**DUGOUT CANYON MINE
PACE CANYON FAN PORTAL FACILITIES
AMENDMENT
C/007/039**

MARCH 2005

Technical Review Deficiencies
Dugout Mine - Pace Canyon Fan Portal
Task ID# 2104

PLATE 2-3A ALTERNATE TOPSOIL STORAGE SITE

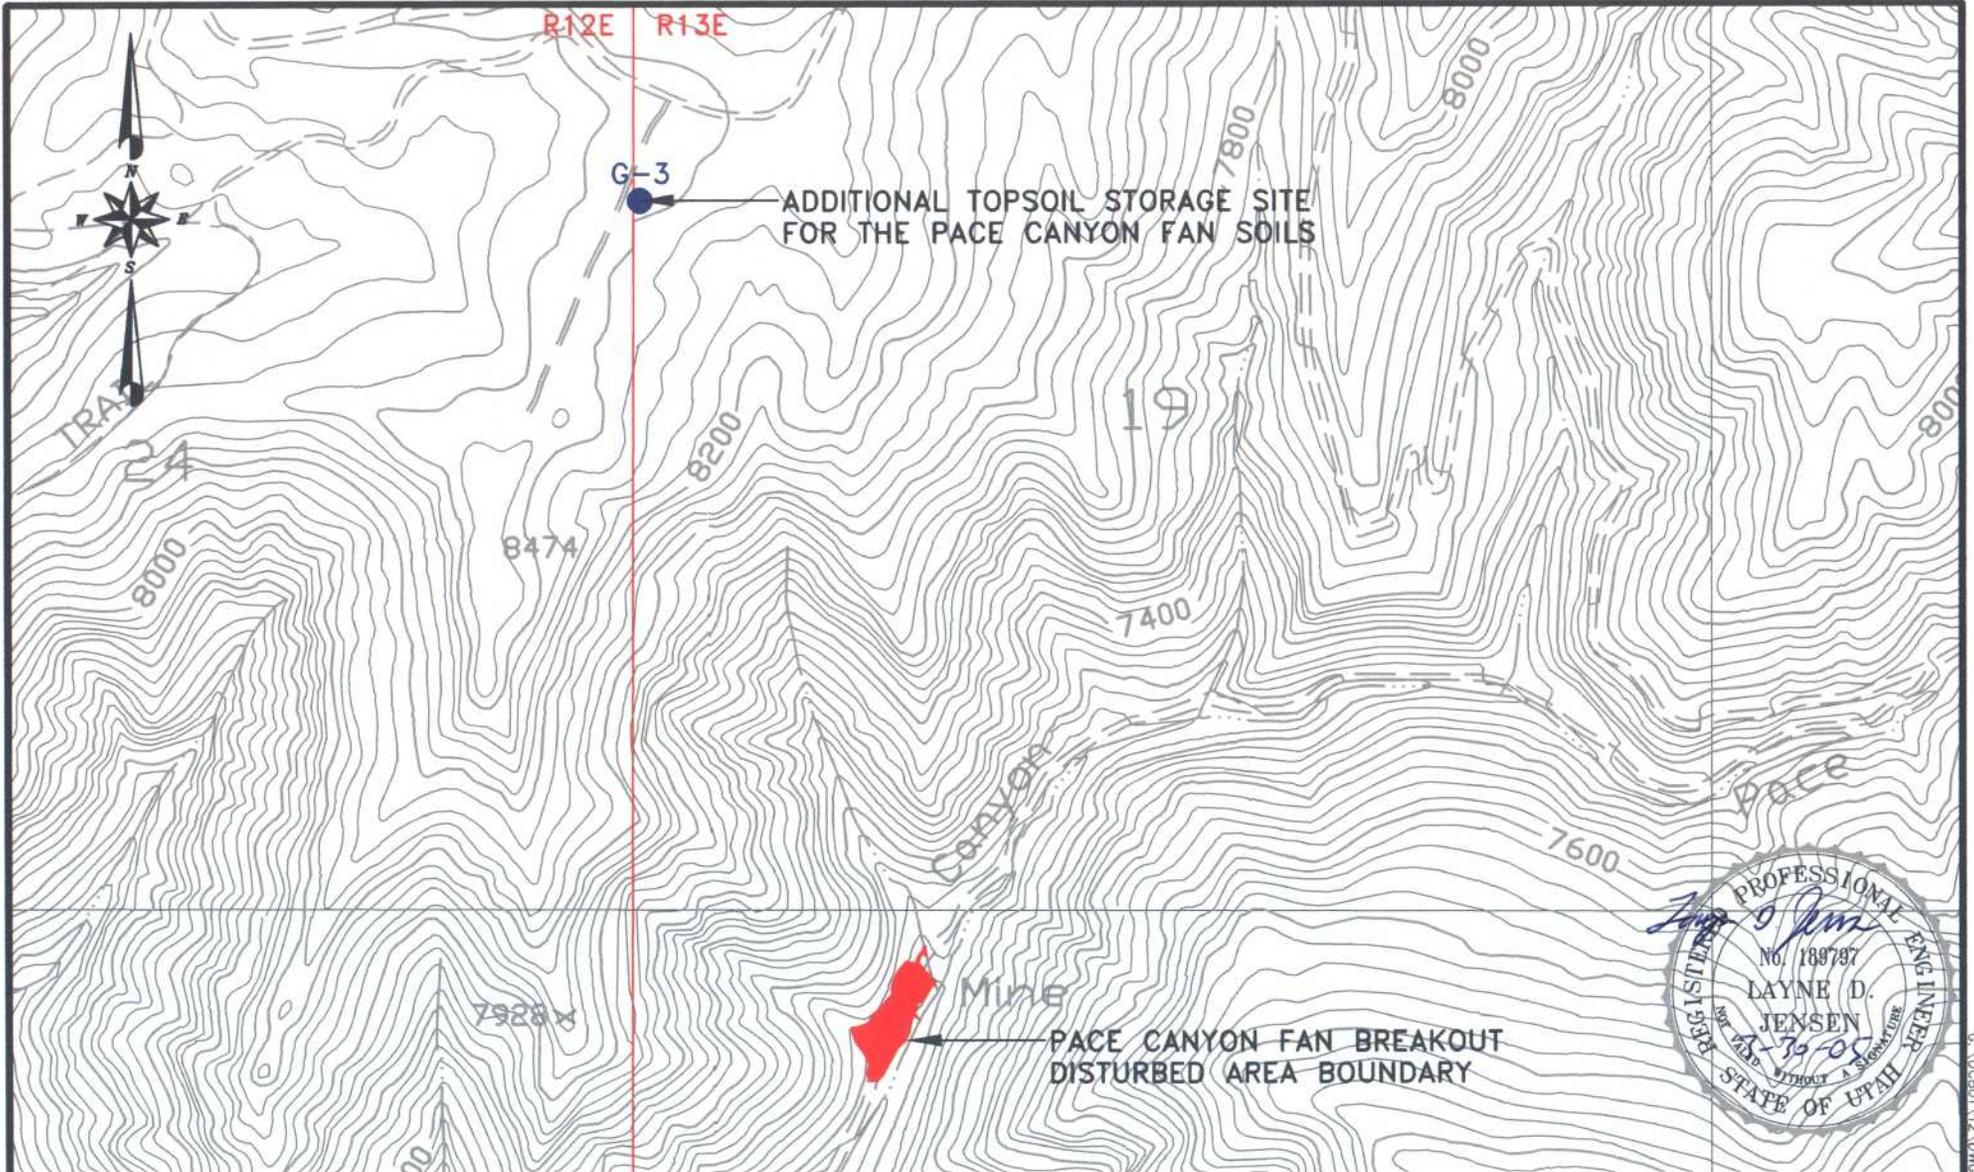
R645-301-234.210, Show on a plate the location of temporarily stockpiled topsoil (as described in Section 242.100, above the portal and along the channel diversion area for immediate replacement after construction of the portal and channel diversion). [PWB]

1206 CY < 2,128 ∴ 922 CY will need to be hauled to an alternate storage site.

DRAWING OR
MAP NUMBER
PLATE PC5-4

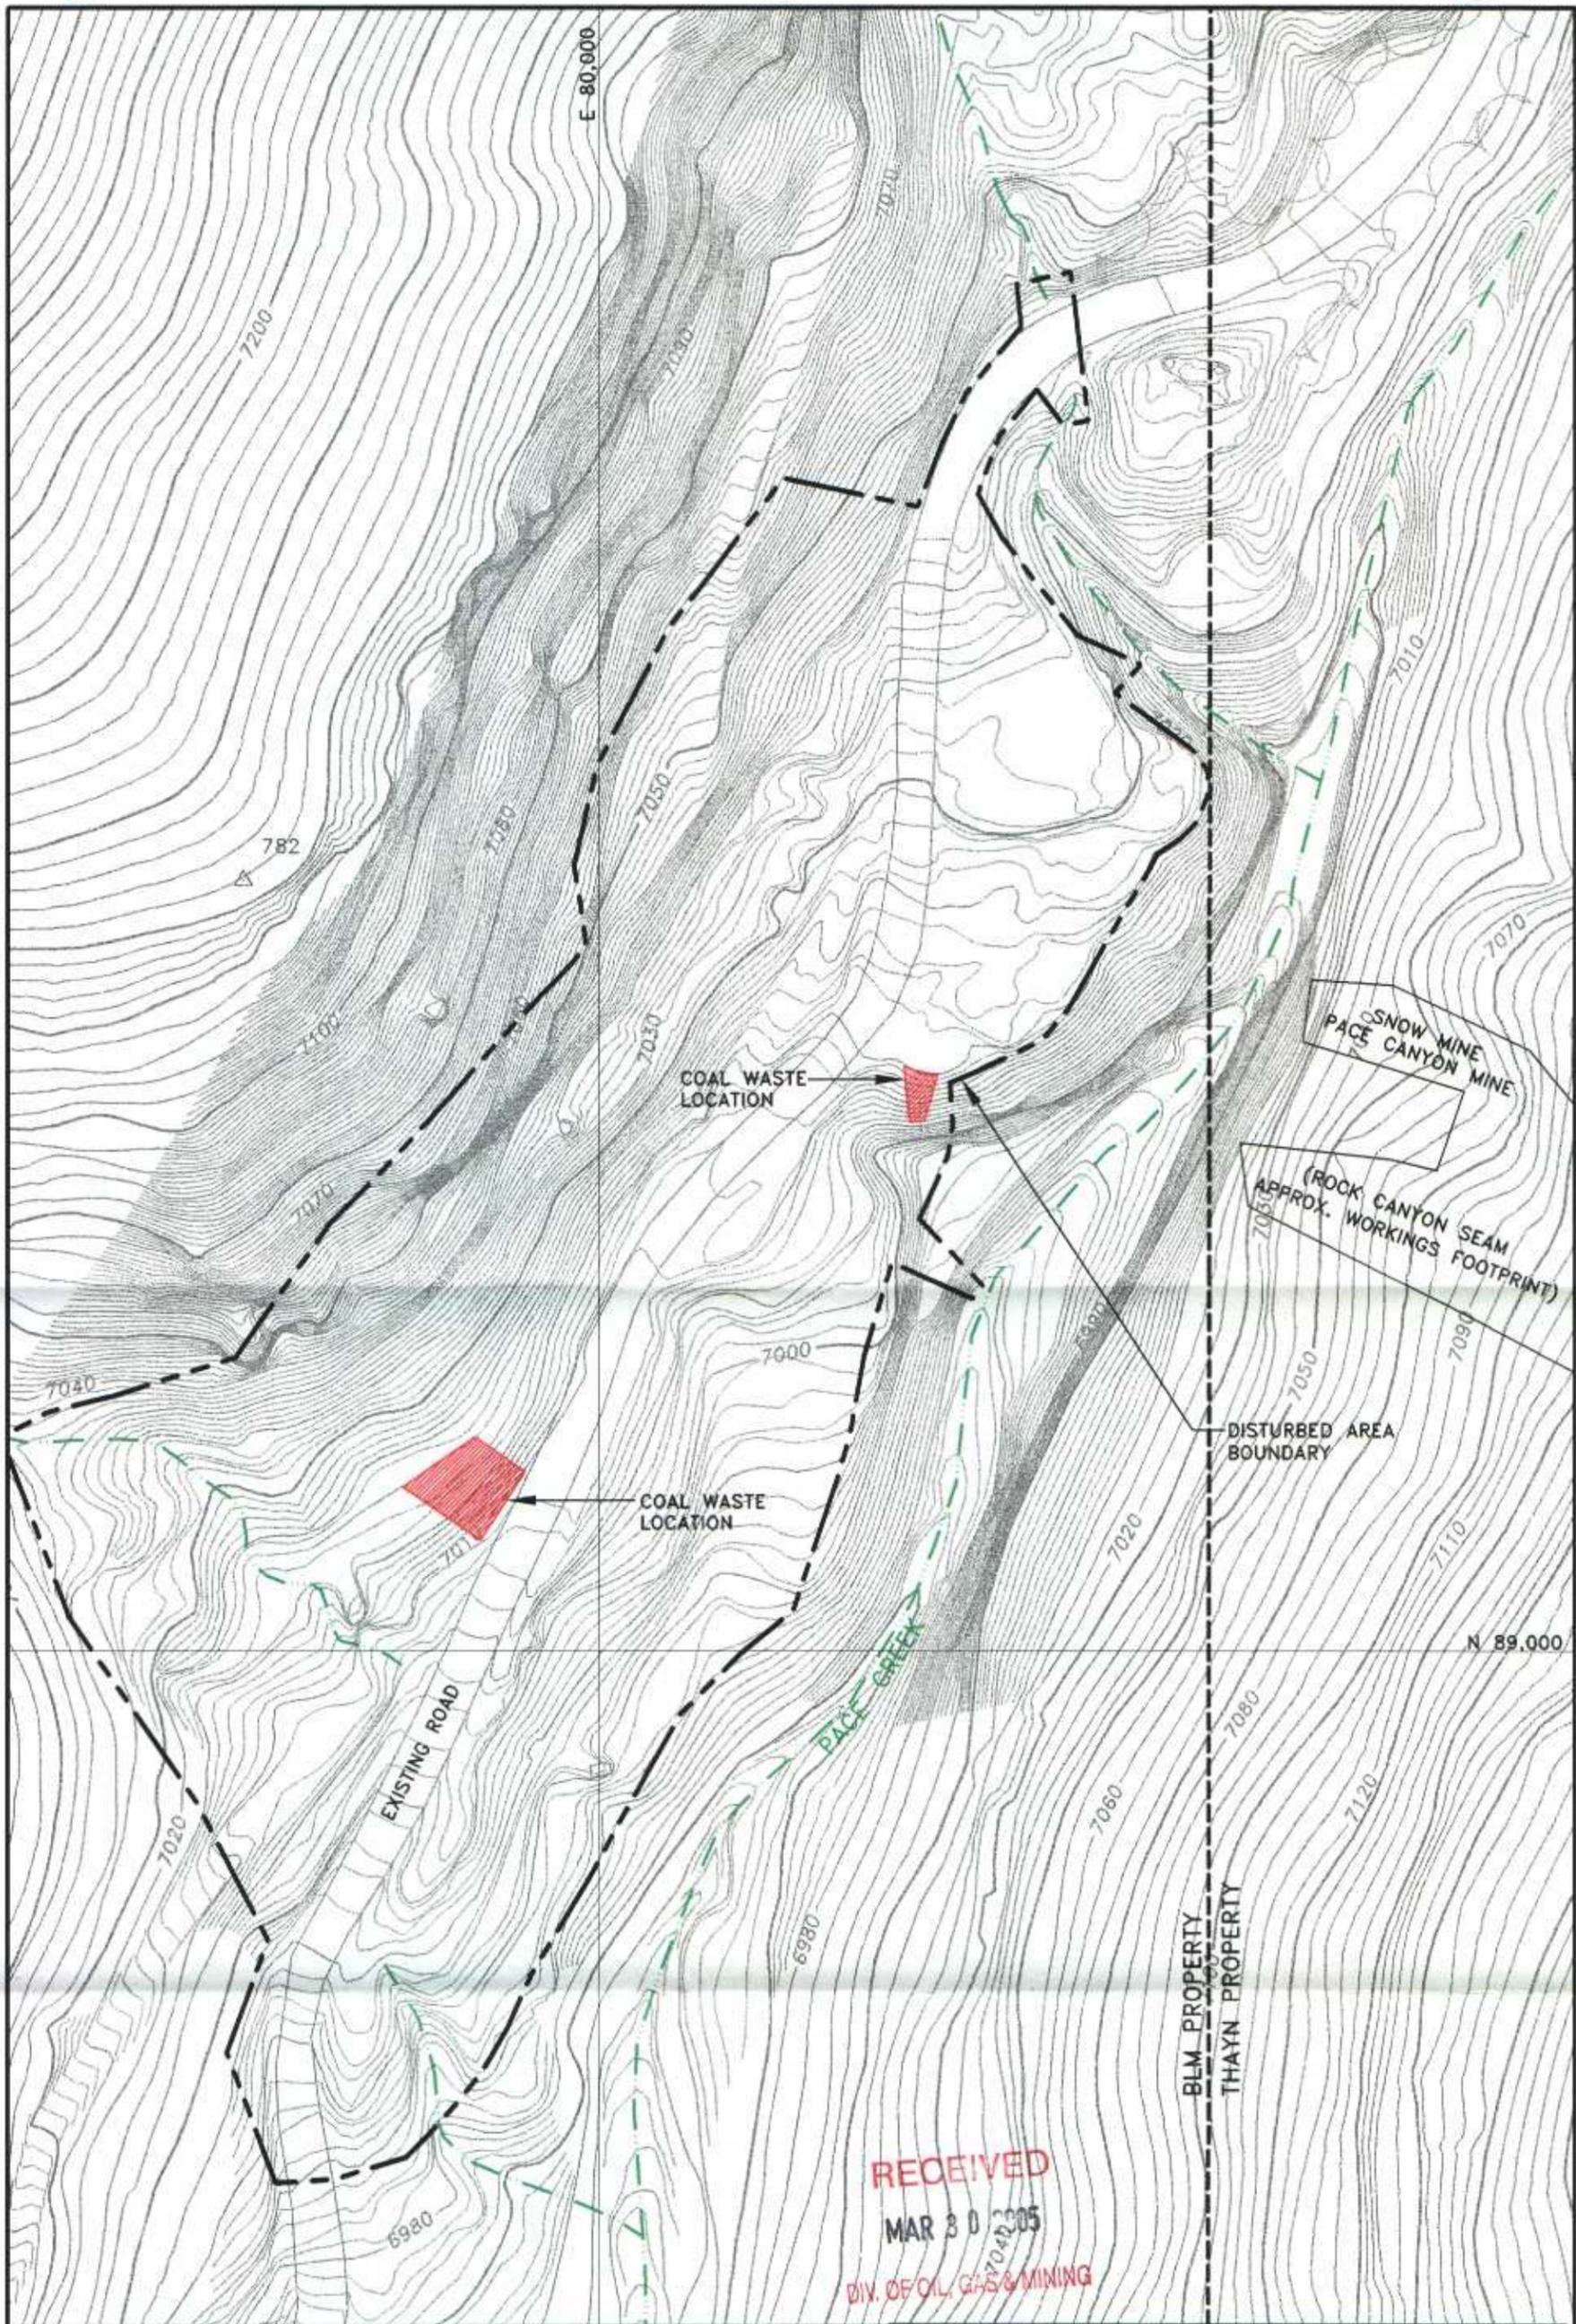
R645-301-411.110, Plate PC5-4 (pre-disturbance area map) must indicate the location of mine dumps within the Snow Mine disturbed area. Plate 4-1, LAND USE MAP in the MRP must be updated to include the main livestock watering source, and the holding corral outside the Pace Canyon disturbed area. [PWB]

Refer to Plate PC5-4. Refer to Section 411.110 and Plate 4-1.
